**LEBANON PLANNING BOARD
MAY 12, 2025 - 6:30 PM
COUNCIL CHAMBERS, CITY HALL OR
REMOTE VIA VIRTUAL PLATFORM
LEBANONNH.GOV/LIVE**

CITY OF LEBANON ~ PLANNING & DEVELOPMENT

Staff Memorandum – PB2025-21-SPR

PLAN DATE: FEBRUARY 24, 2025
SCALE: 1" = 50'
PROJECT NO.: 242661
SHEET S1 OF S1

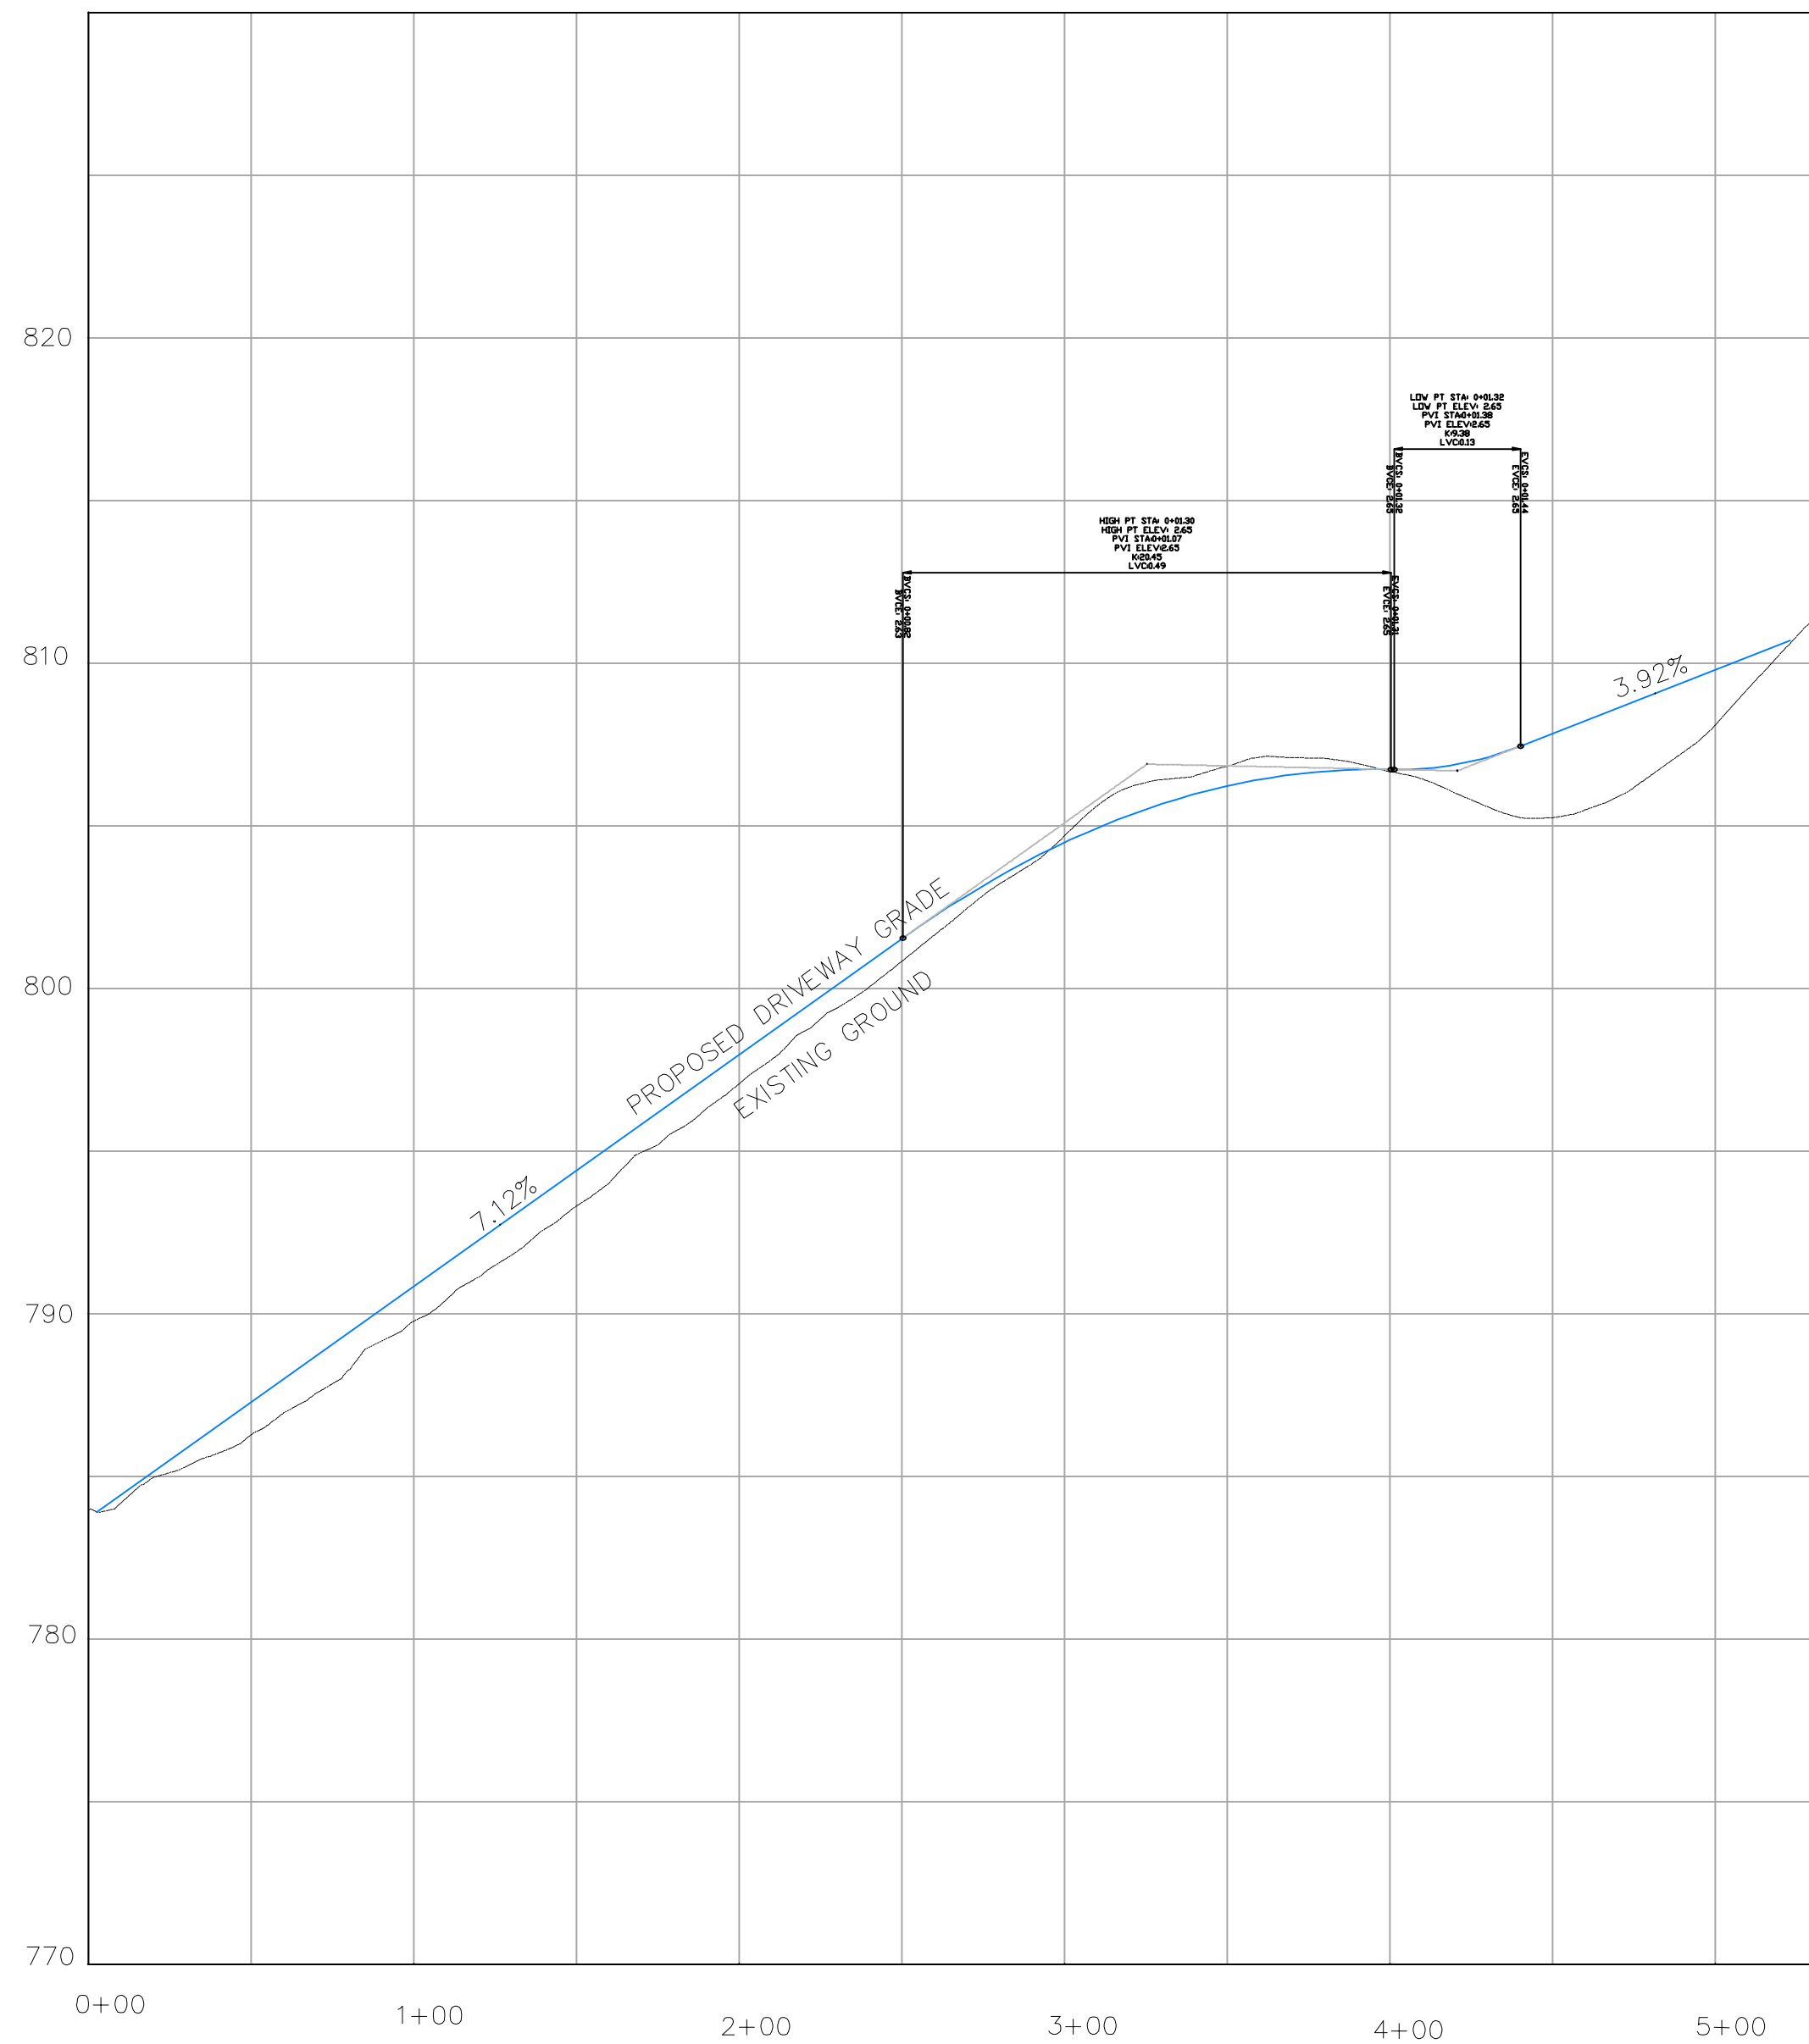
6. Amend the plat (i.e. Sheet 2 (S1) of the current 3-sheet plan set) to:
 - a. Add a note on the plat to address Section 7.7.A.4.e (“All persons holding conservation, preservation, or agricultural preservation restrictions (as defined under RSA 477:45) on the subject property. (NOTE: When there are no such restrictions on the subject property, the Applicant shall provide a definitive statement to that effect.)) **Note added.**

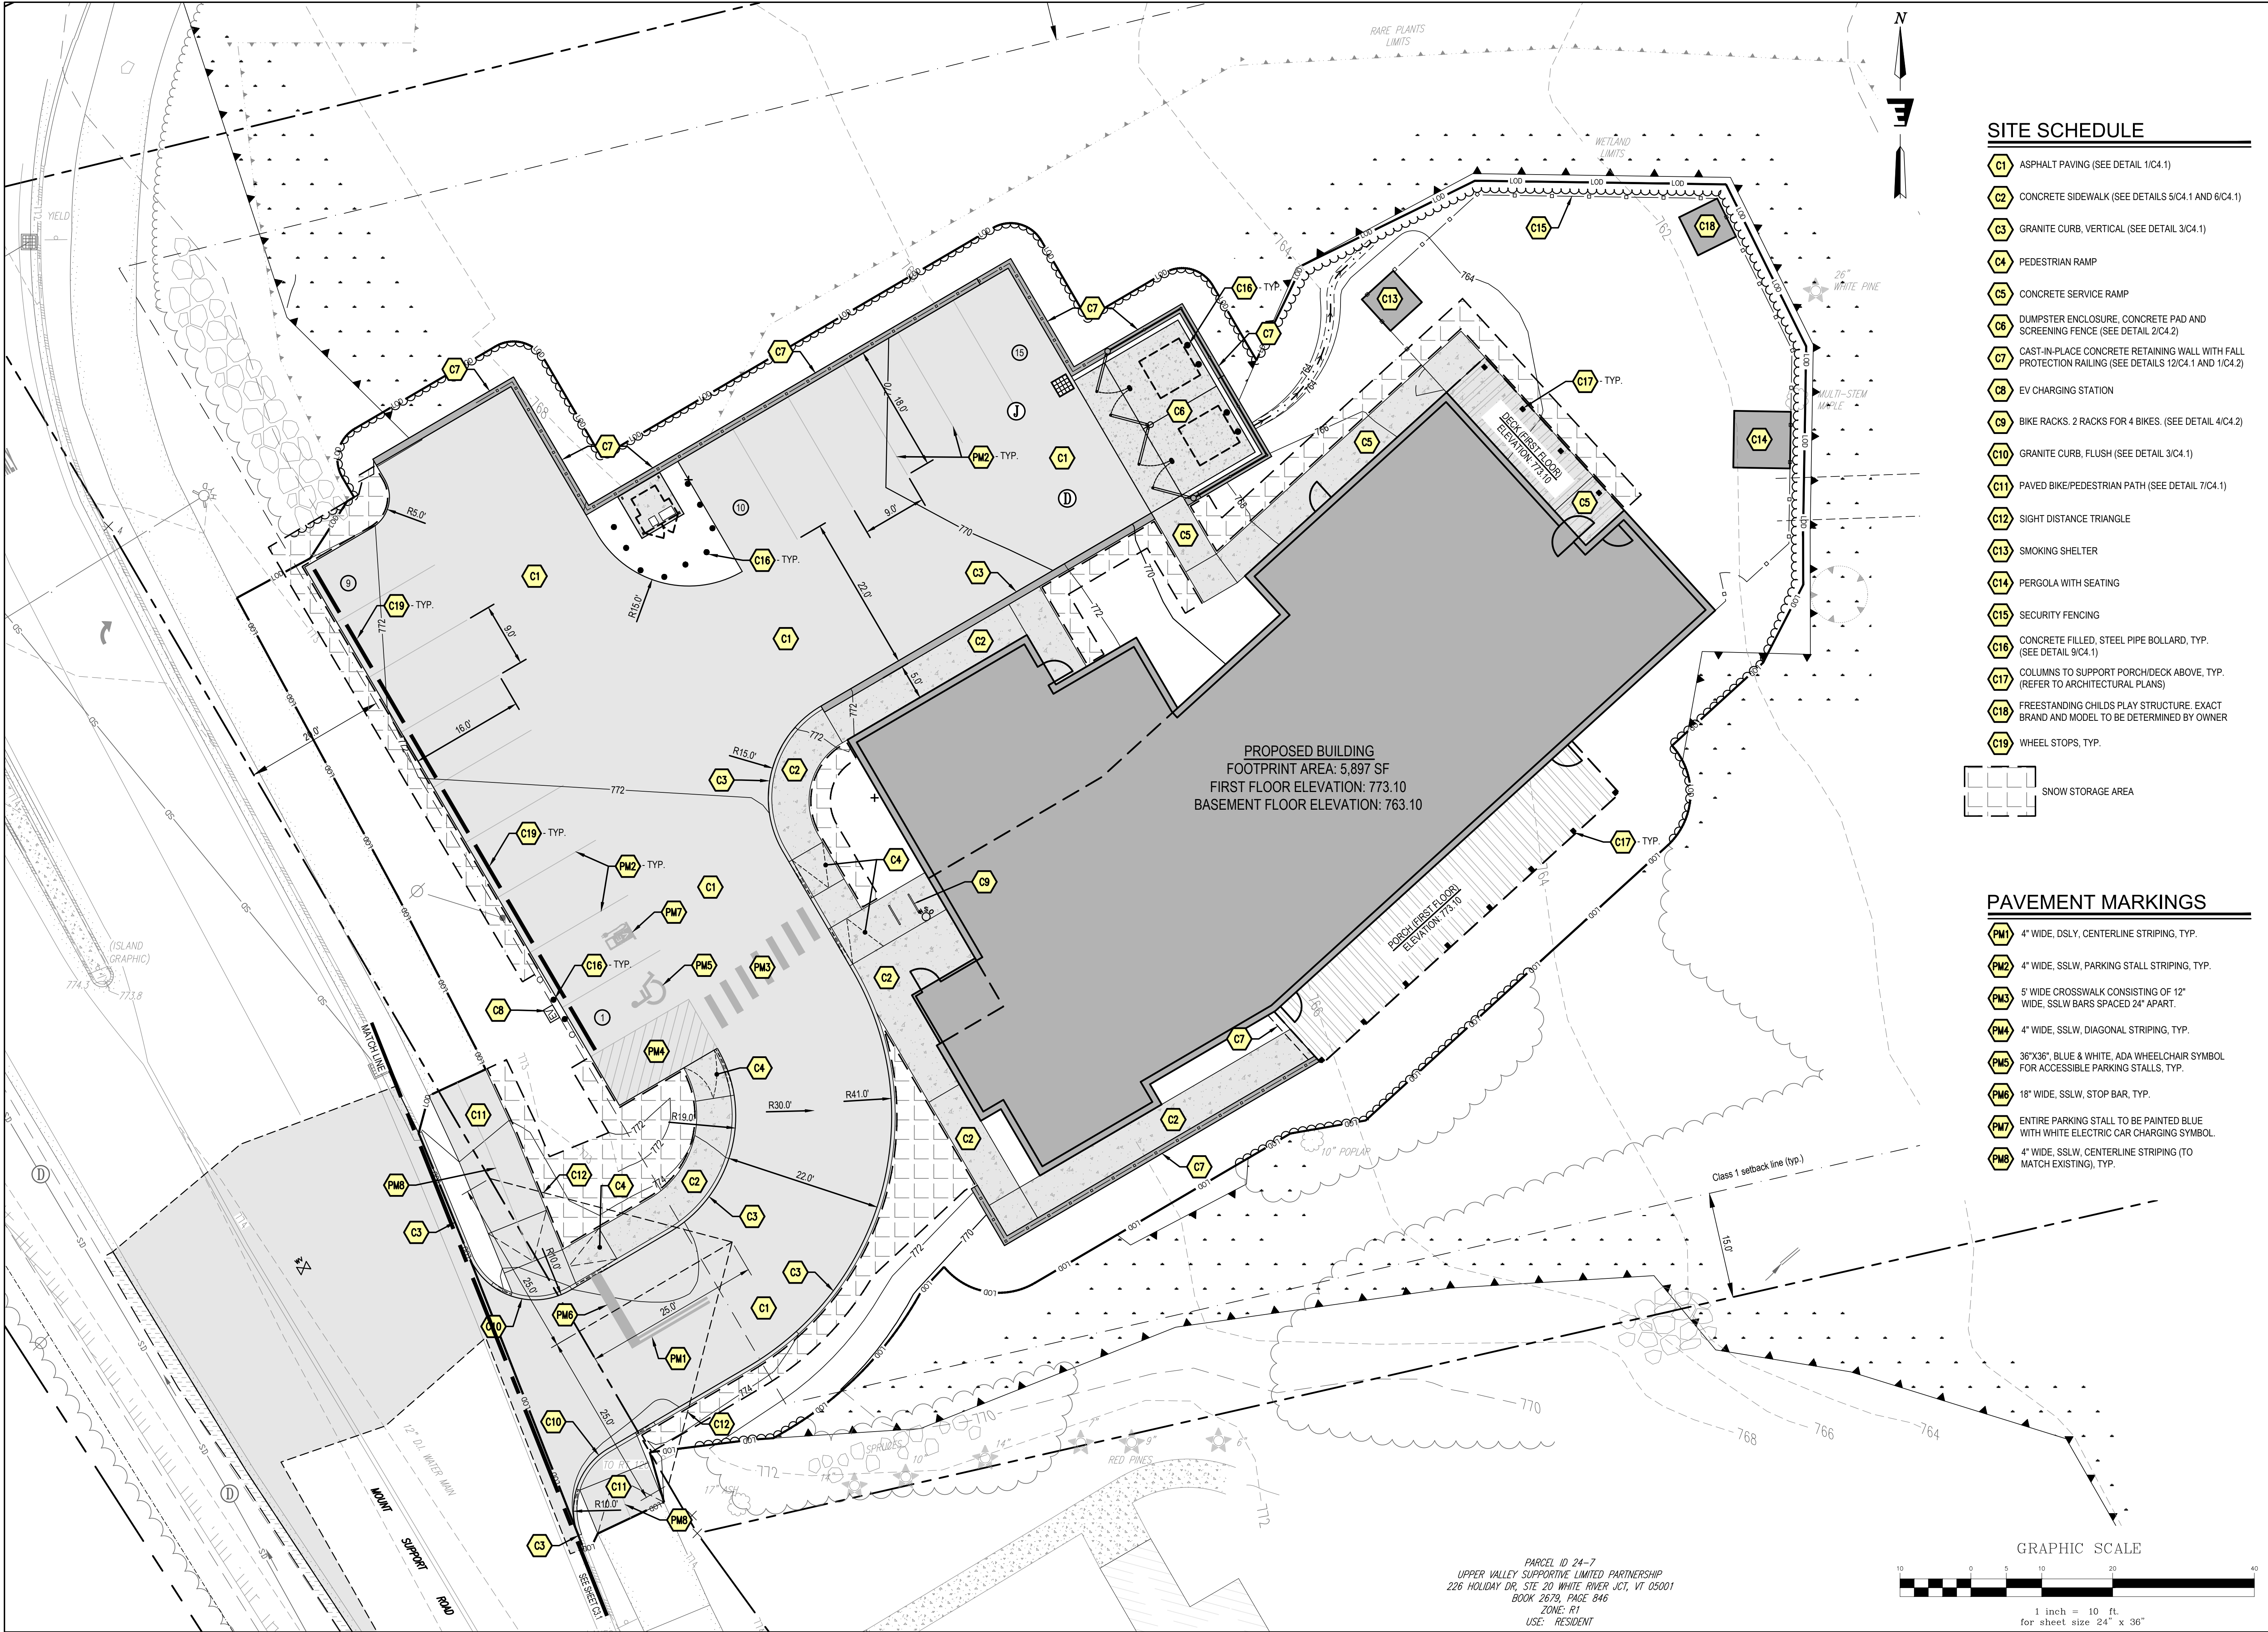
- Responses to items in the separate Site Plan Checklist are provided in the version of it included with this resubmission.
2. *The lack of an easement agreement with respect to the multi-use path (as noted on Sheet 3 (C1.1)) should be rectified/addressed in connection with the site plan application approval.*

- Per a follow up email from Tim Corwin on 4/22/2025, sheet C1.1 now includes a note indicating that this easement is in the works.
3. *An agreement or agreements with the City relative to the ownership and maintenance of and access to the sewer service line within Mount Support Road should be clarified - as much as possible - with the Department of Public Works prior to the public hearing.*
